15a Parliament Hill
New House
30.06.2017
Proposed
Section: B/2

P/1:50/202/B/2/revA

B/2

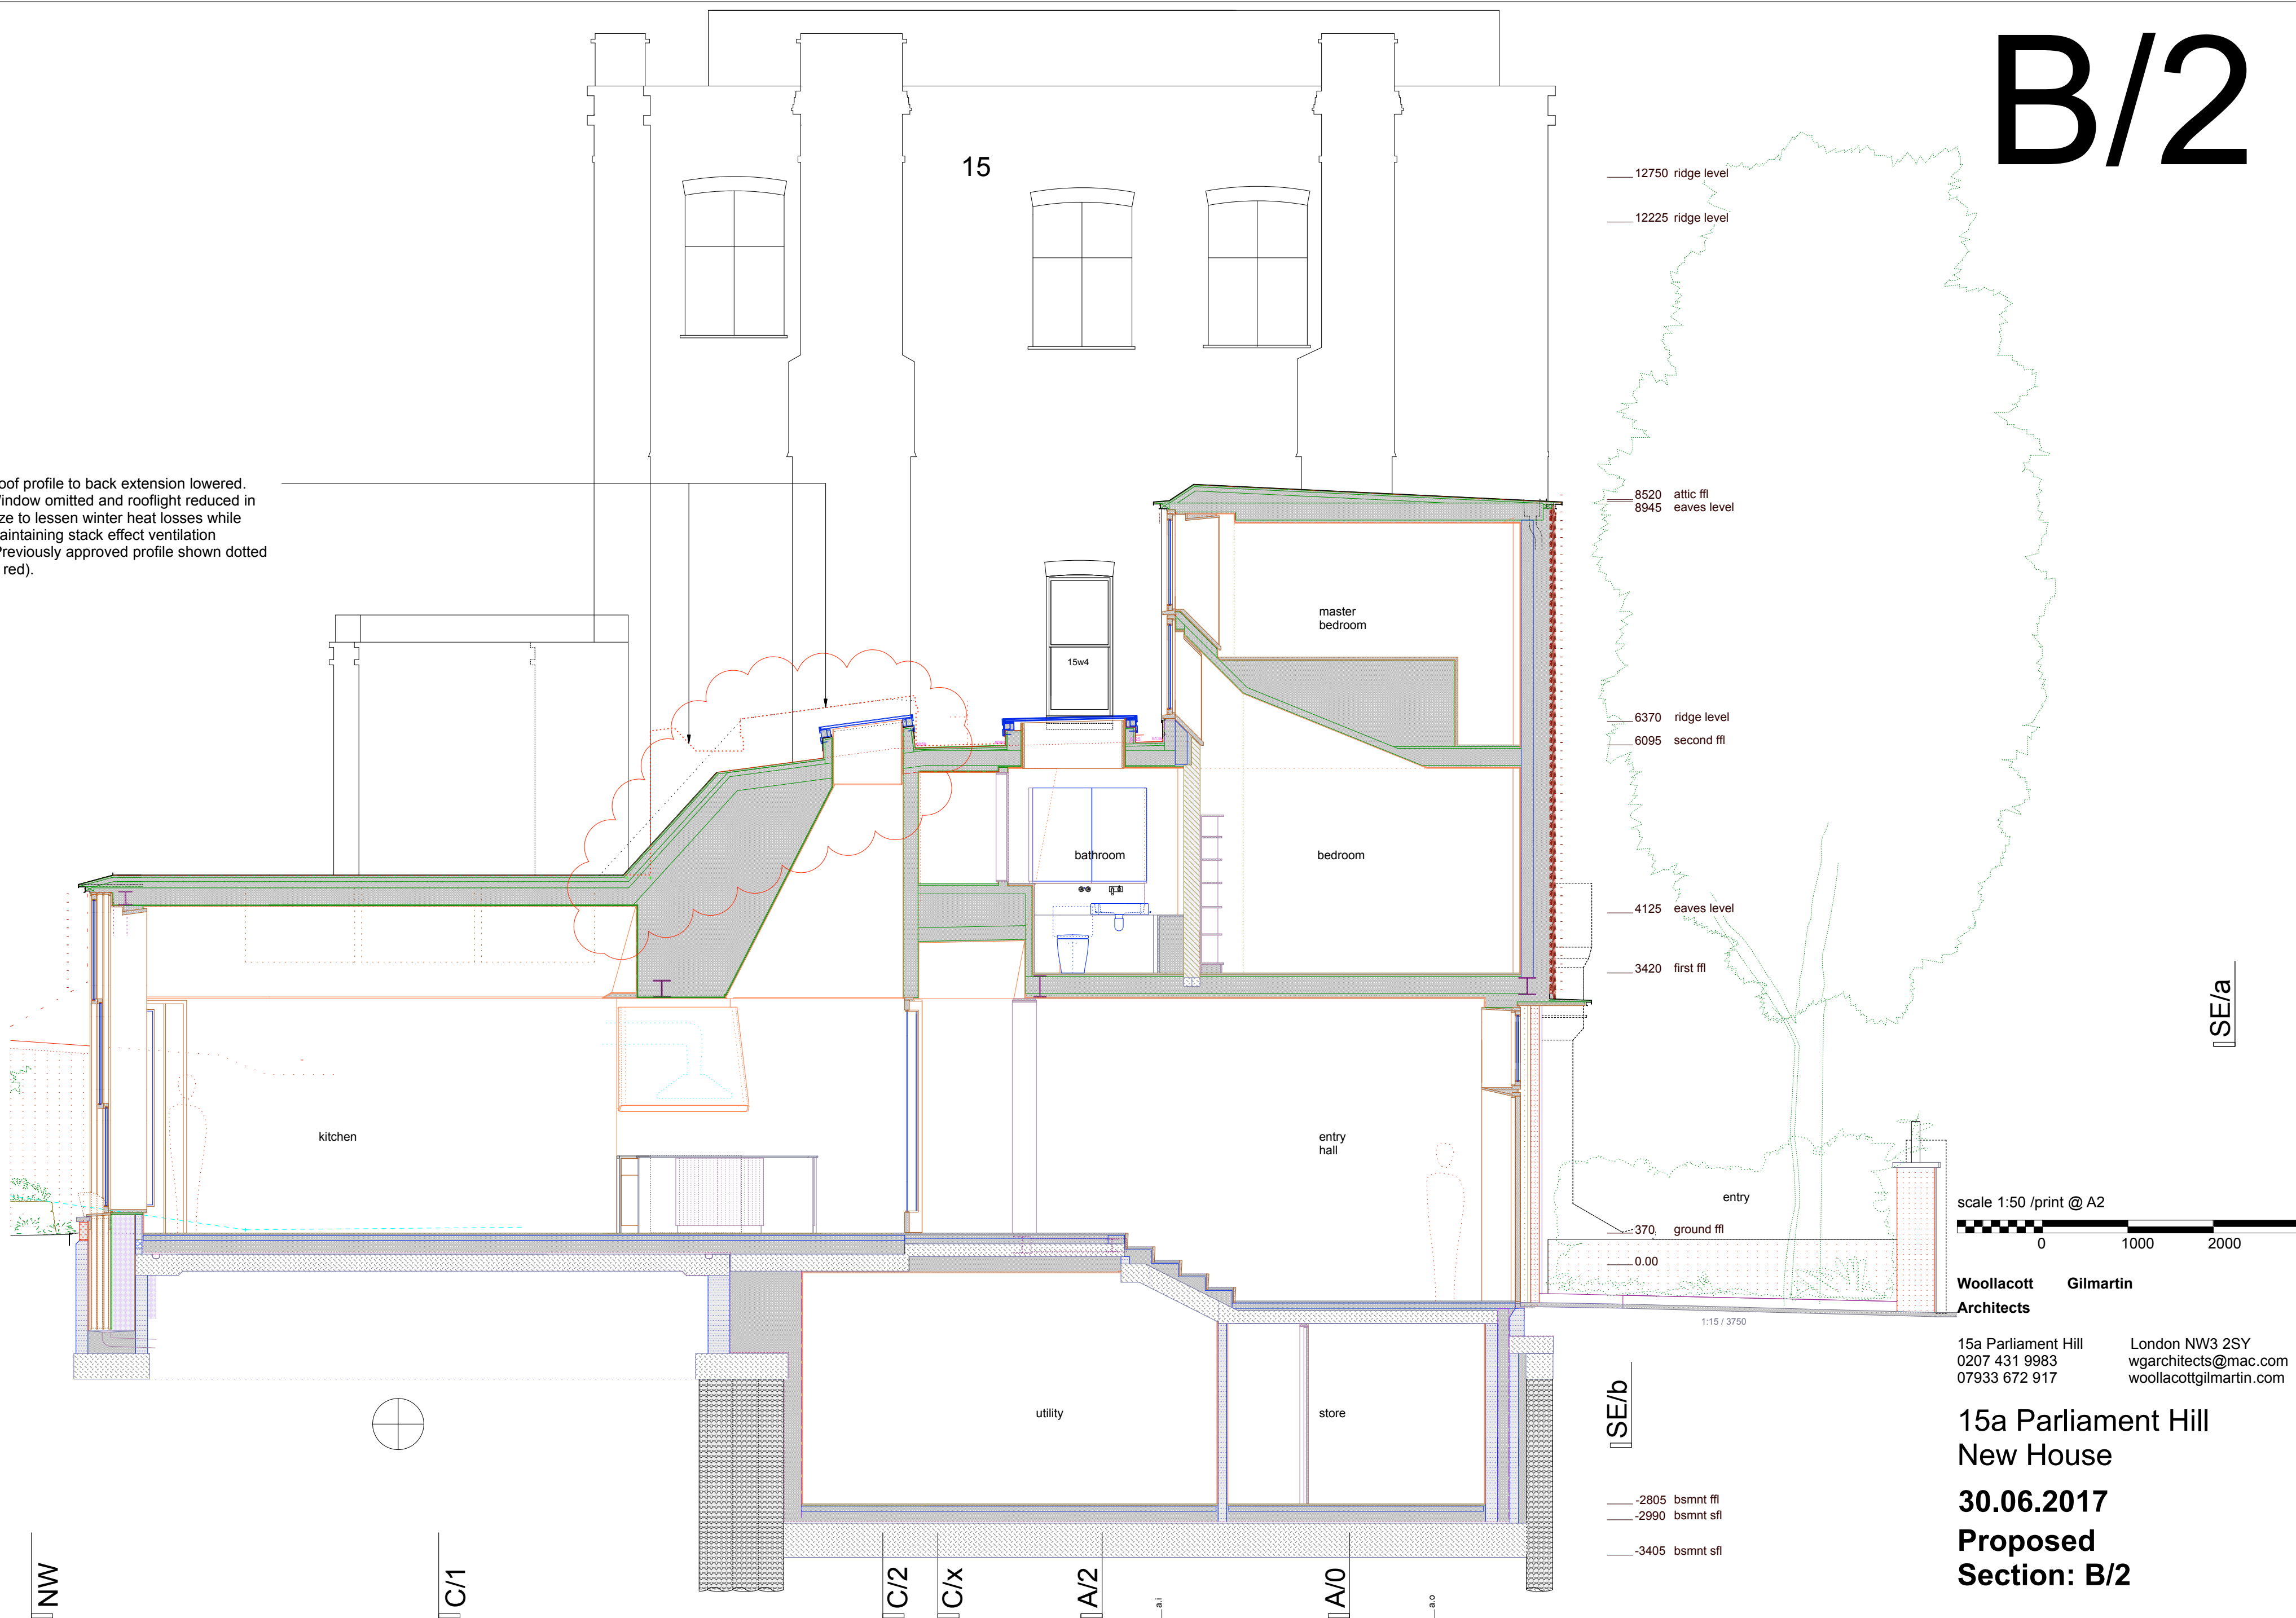
Roof profile to back extension lowered.
Window omitted and rooflight reduced in
size to lessen winter heat losses while
maintaining stack effect ventilation
(Previously approved profile shown dotted
in red).
